INDESIT company

Model type:
LKF710XEU/HA

Commercial code:
F054108

2270210 Exploded views

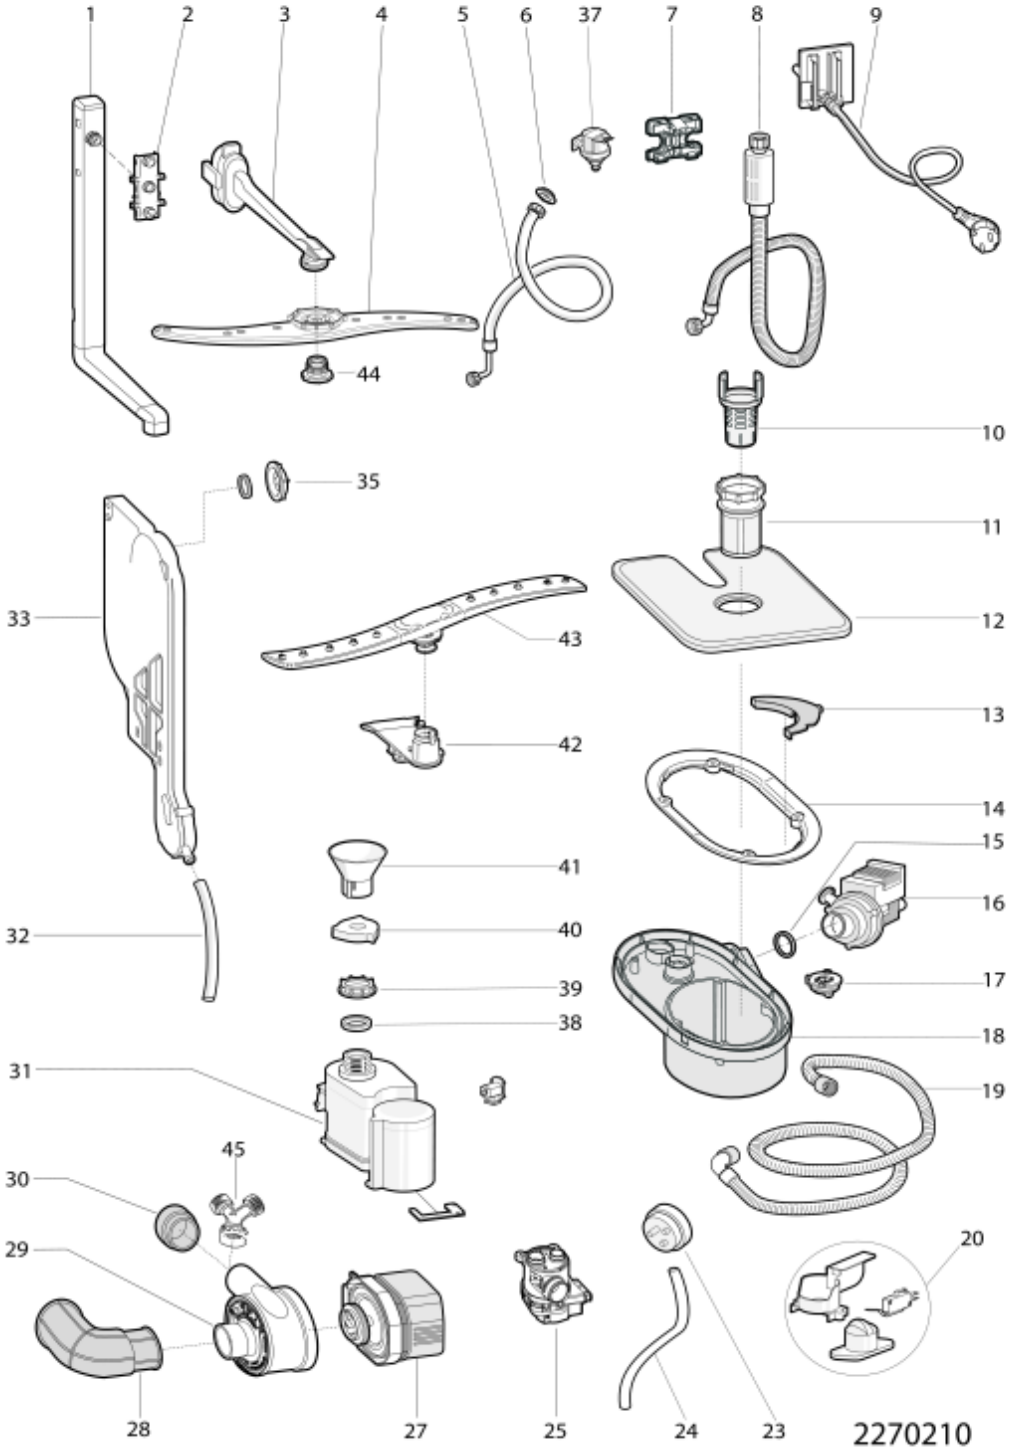
n4513g02: INTRODUCTION OF NEW SYNCHRONOUS MOTOR

A new electropump has been introduced in the synchronous motor. This is perfectly interchangeable with the previous one, only the dowel has been modified improving its quality.

New motors have new codes:

Old New
C00256523 -> C00302800
C00256525 -> C00302798
C00272798 -> C00302796
